**EVAPORATION
PONDS**

**RE: APPROVAL WITH MODIFICATIONS
GEOTECHNICAL ENGINEERING REPORT
WESTERN REFINING SOUTHWEST INC., GALLUP REFINERY
EPA ID # NMD000333211
HWB-WRG-20-001**

Re: **Geotechnical Engineering Report
Marathon Petroleum Company Gallup Refinery
Evaporation Pond Nos. 6, 7 and 9
92 Giant Crossing Road
Gallup, New Mexico
Terracon Project No. 66195049**

UNCONFINED COMPRESSION STRENGTH OF COHESIVE SOIL (ASTM D 2166)

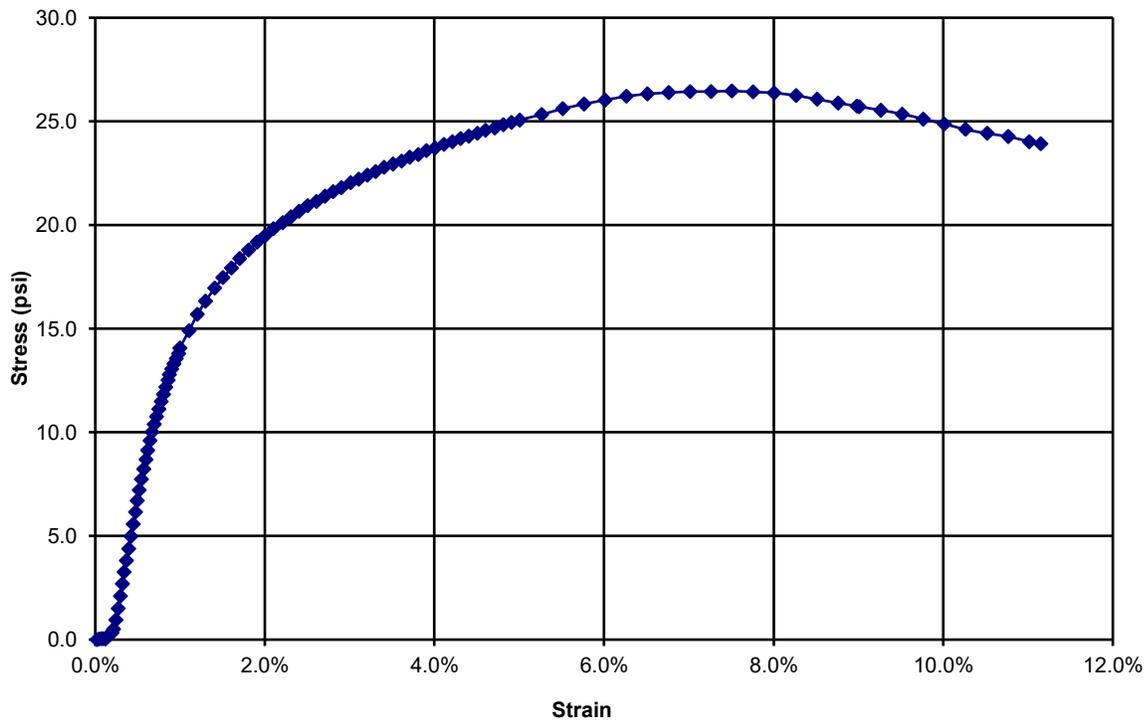
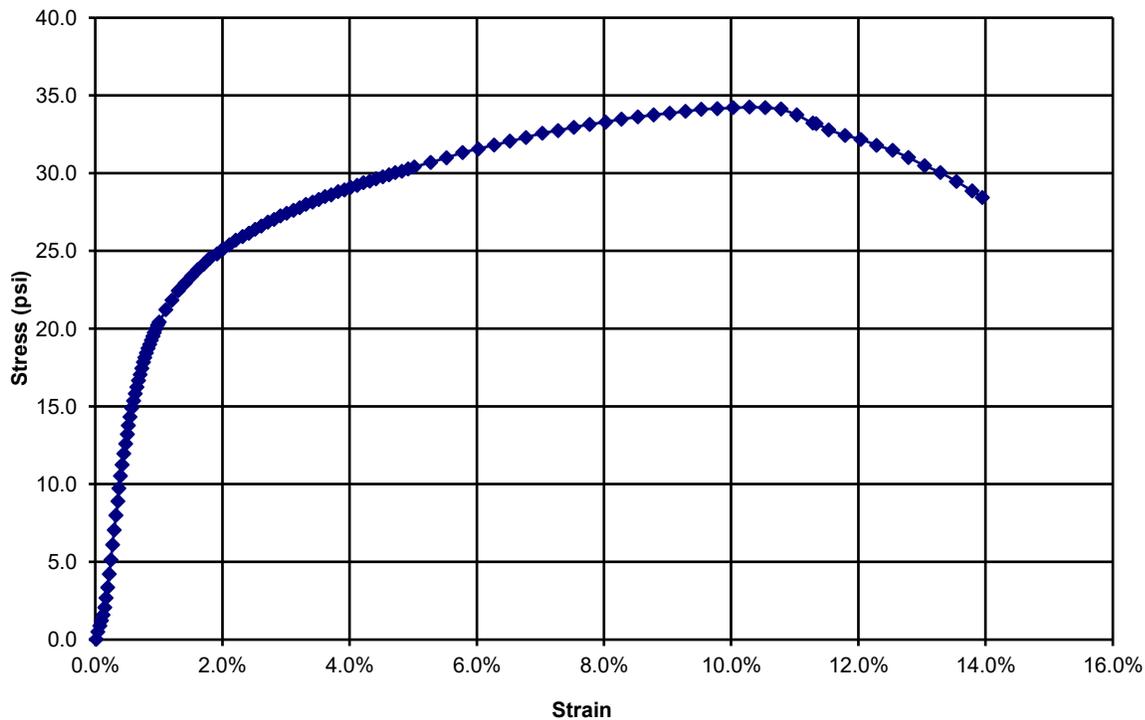
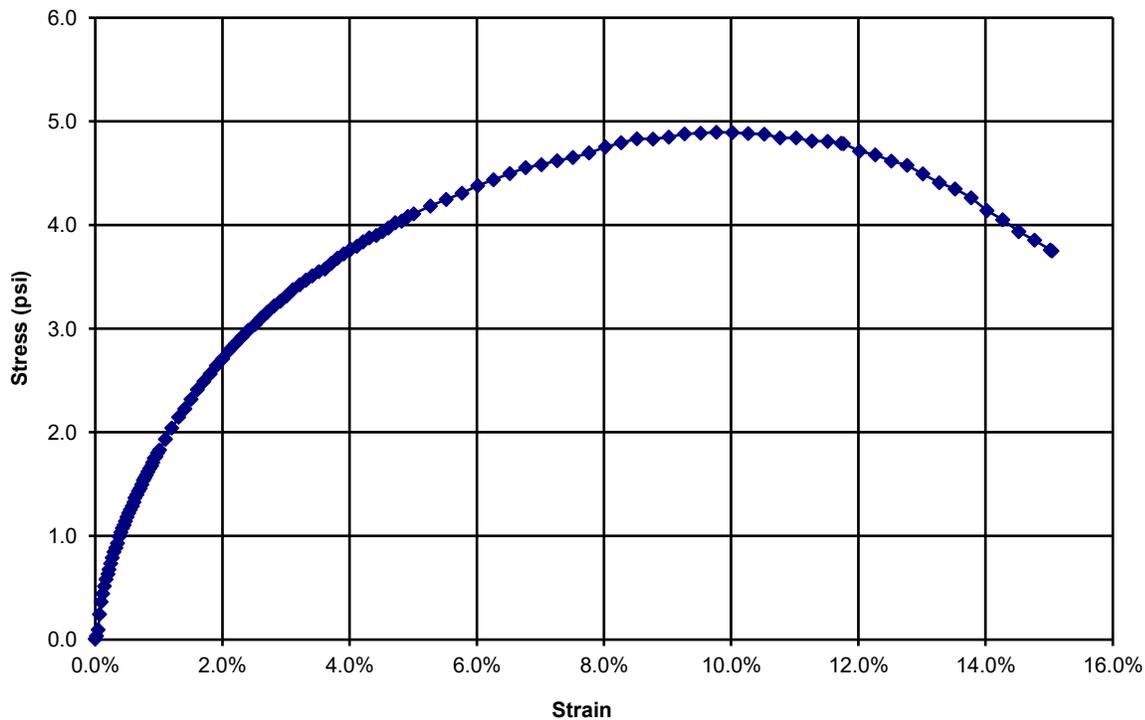
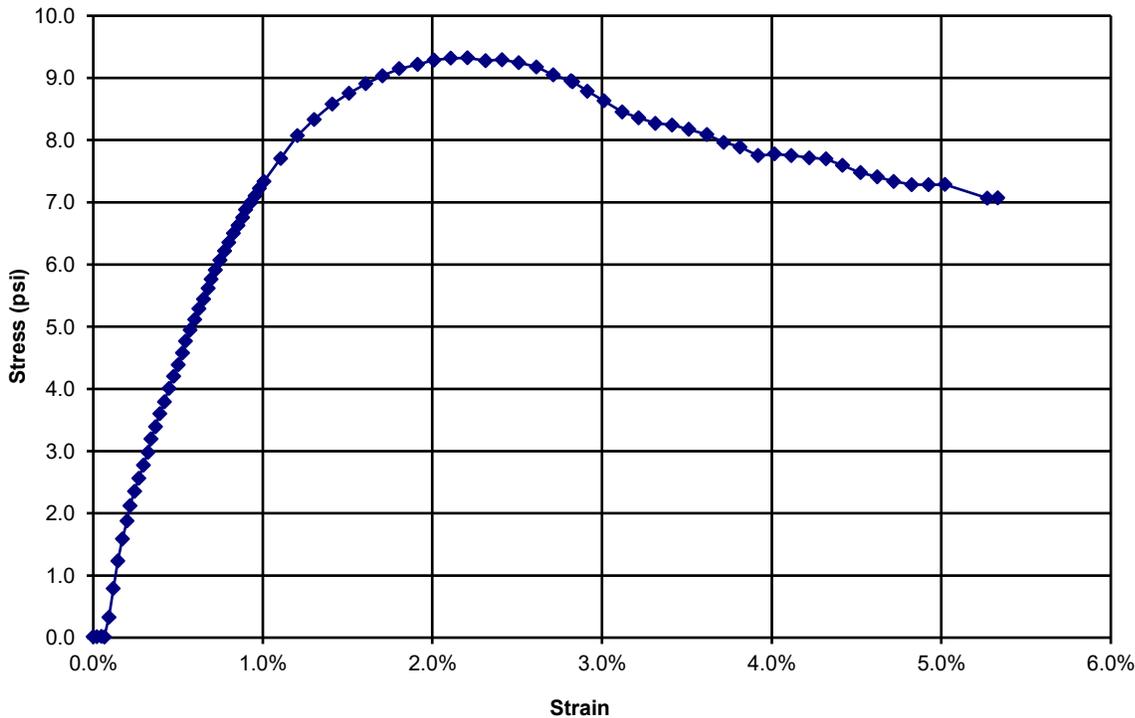
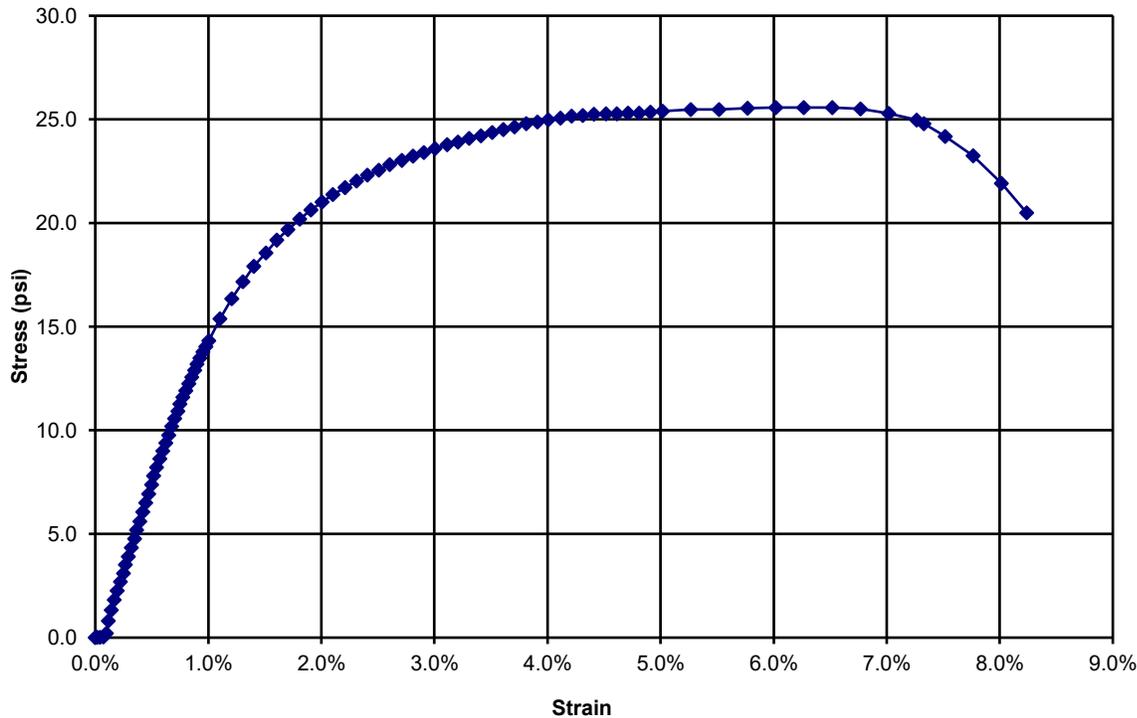
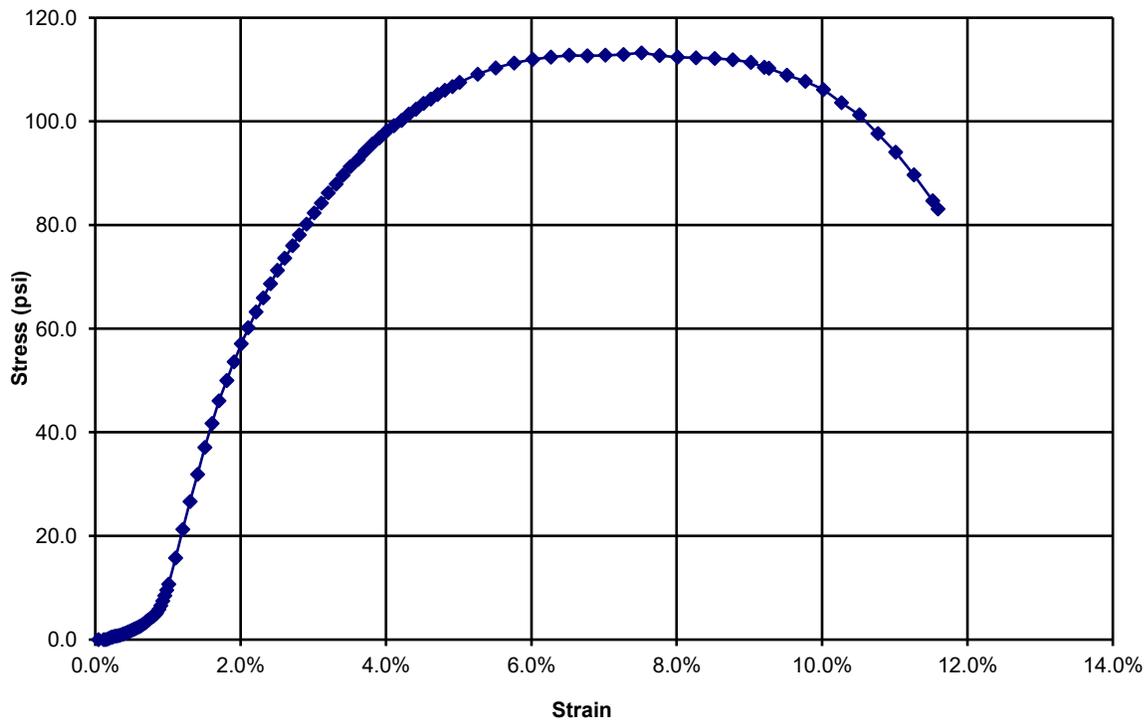
In Appendix B, *Laboratory Testing*, Exhibits B-10 through B-23 are labeled as both Consolidated Drawing Triaxial Compression Tests and Unconfined Compression Strength. Clarify which test was performed on the samples in the response letter.

**Marathon Petroleum Company Gallup Refinery
 Pond 7 - Slope Stability Analysis
 Morgenstern Price Limit-Equilibrium
 Water Level: Updated Piezometer Readings dated 12/11/19
 Static Conditions**

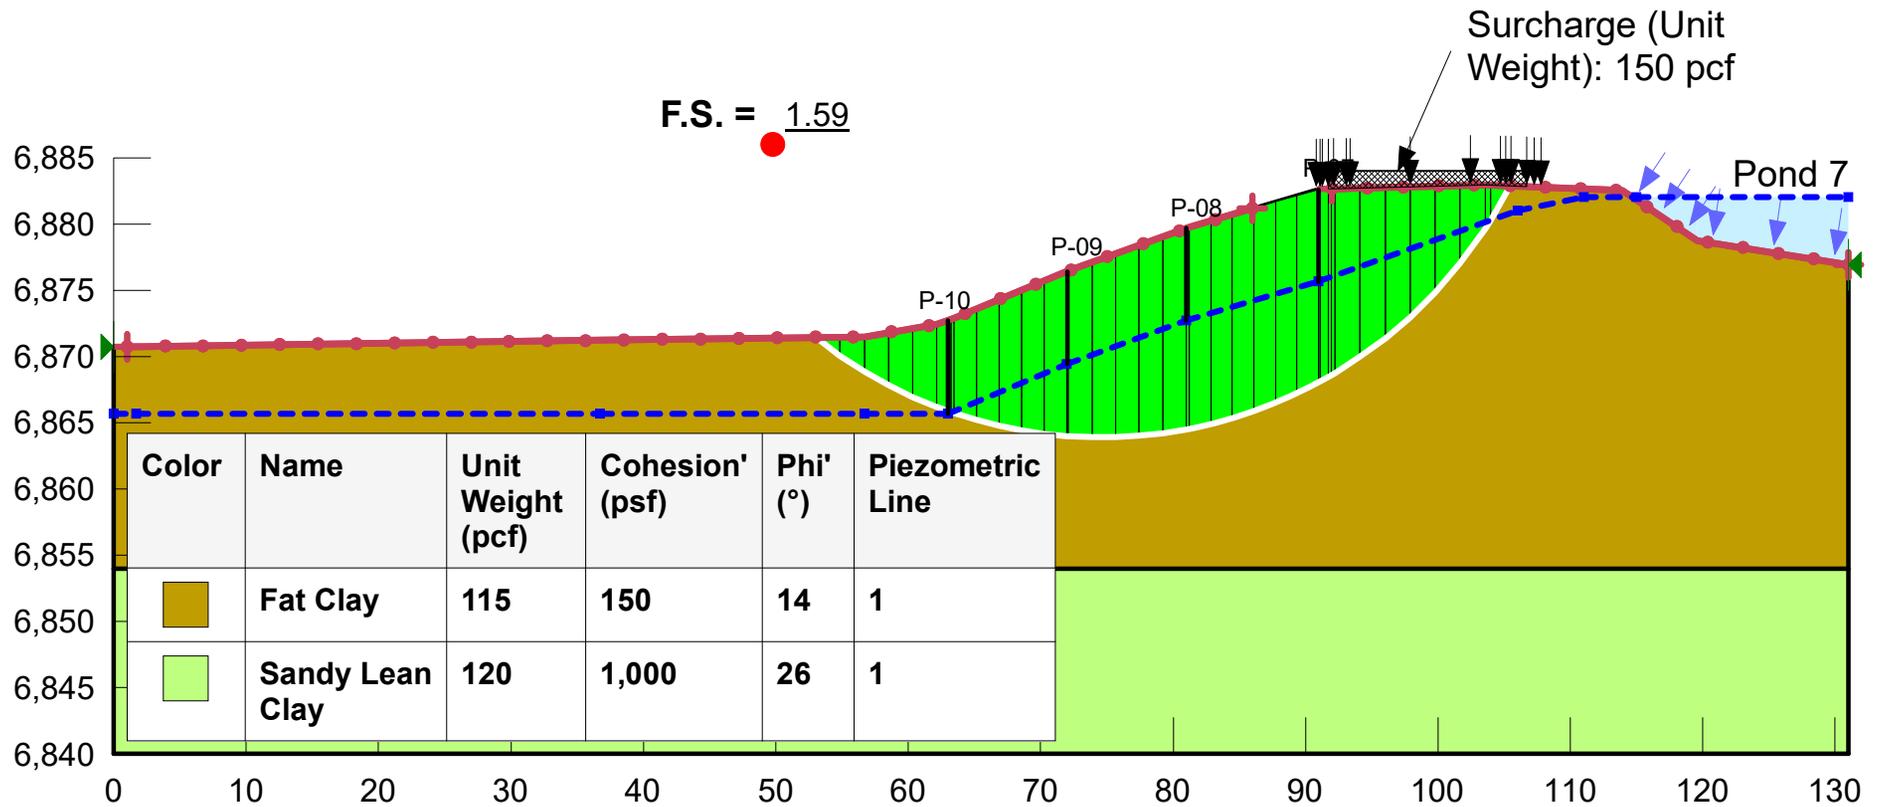
In Appendix D, *Slope Stability Analyses*, Exhibit D-3 indicates that there is minimal freeboard at Pond 7; the pond water level is nearly at the crest elevation. Inadequate freeboard could result in overtopping during a storm event. Breaching and instability caused by erosion may result from overtopping, regardless of the acceptable stability analyses factors of safety. Evaluate whether current water levels provide adequate freeboard and provide a discussion in the response letter.

1. PLAN VIEW OF THE EVAPORATION PONDS WITH PROPOSED PIEZOMETER LOCATIONS AND NUMERICAL SLOPE STABILITY SECTION LOCATIONS
2. ANTICIPATED FIELD WORK AND REPORT SCHEDULE

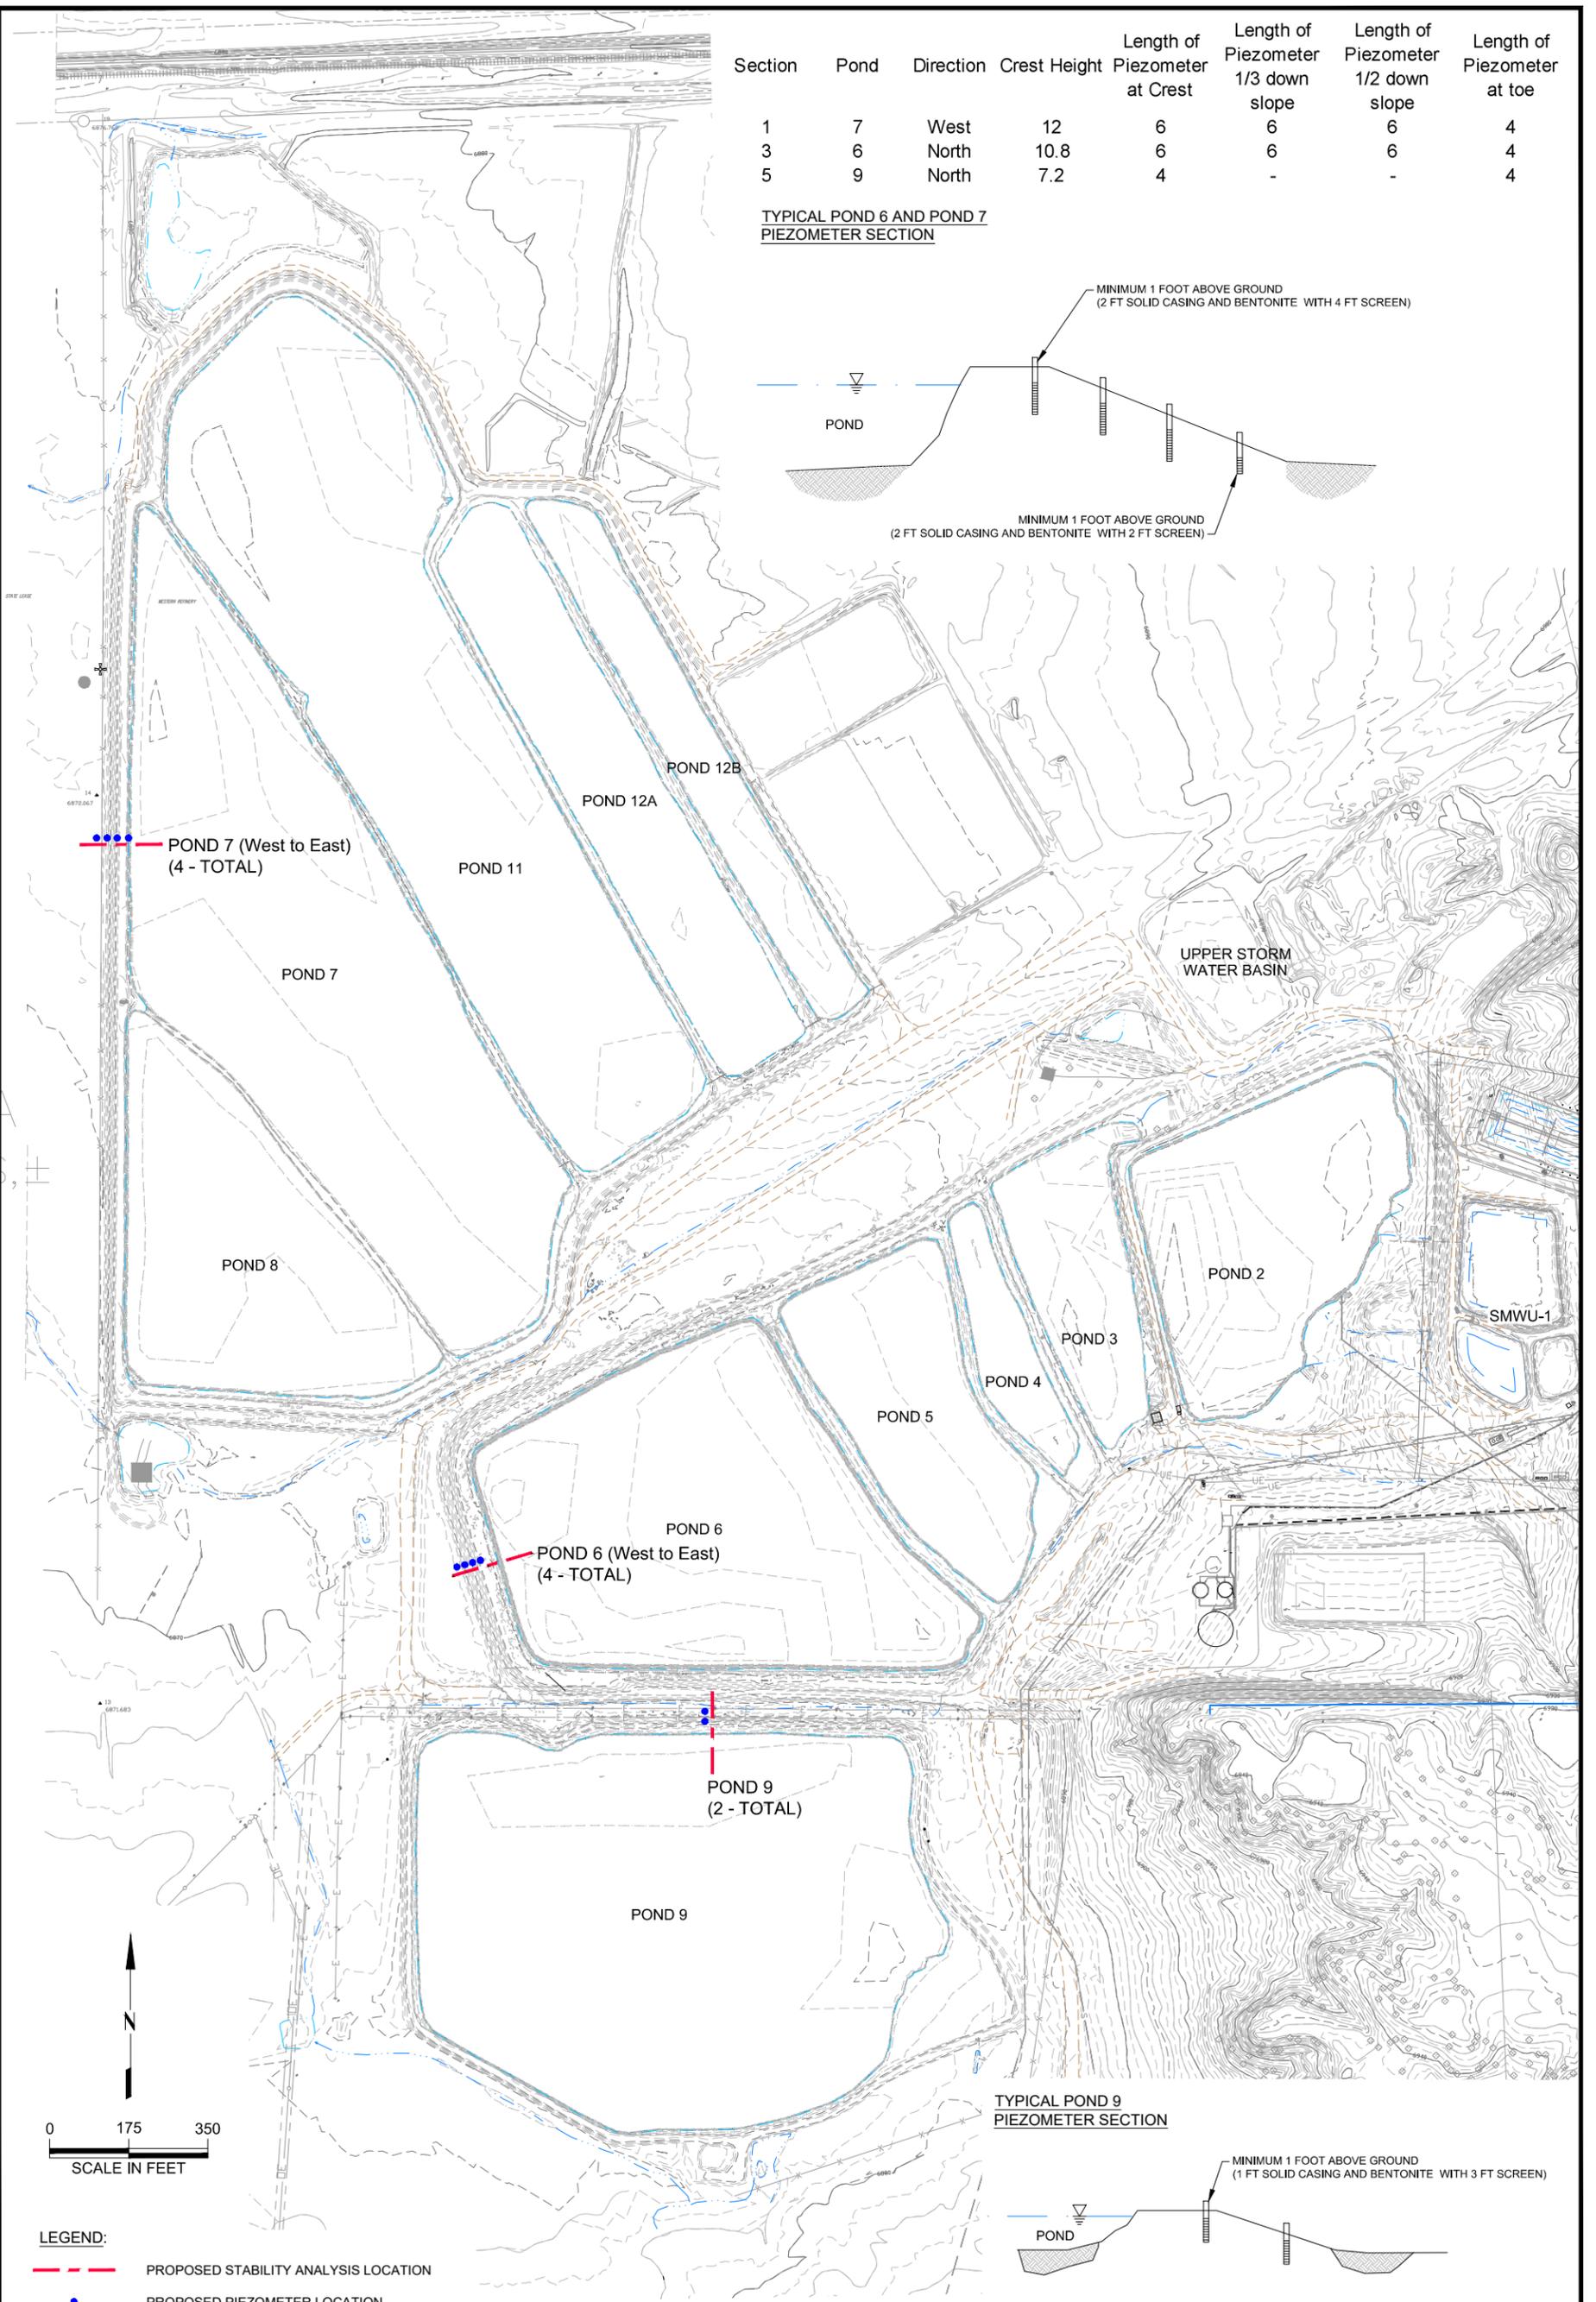
Under the heading "Updated Numerical Slope Stability Analysis", page 1, the Permittee states that "[f]ield investigation activities will begin with installing 10 new piezometers that will be used to complete the updated numerical slope stability analysis." Provide the rationale for the locations selected for the permanent piezometers. The locations correspond to the previous locations of temporary piezometers at Pond 7, Pond 6 (West to East), and Pond 9A. In the report, discuss whether the piezometers are located along berms that have been repaired or upgraded. Additionally, piezometers are proposed for the Pond 7/8 west berm; NMED recommends installing additional piezometers closer to Pond 8 due to concerns of pond water leaching into groundwater at the western end of the evaporation ponds.

Response – The borings will be located at both repaired and upgraded berms. Pond 7 was repaired due to a breach. Pond 9 was upgraded with the placement of additional fill. It is our professional opinion that the proposed number and location of borings are adequate to address the concerns of NMED and perform the necessary analysis. Several borings
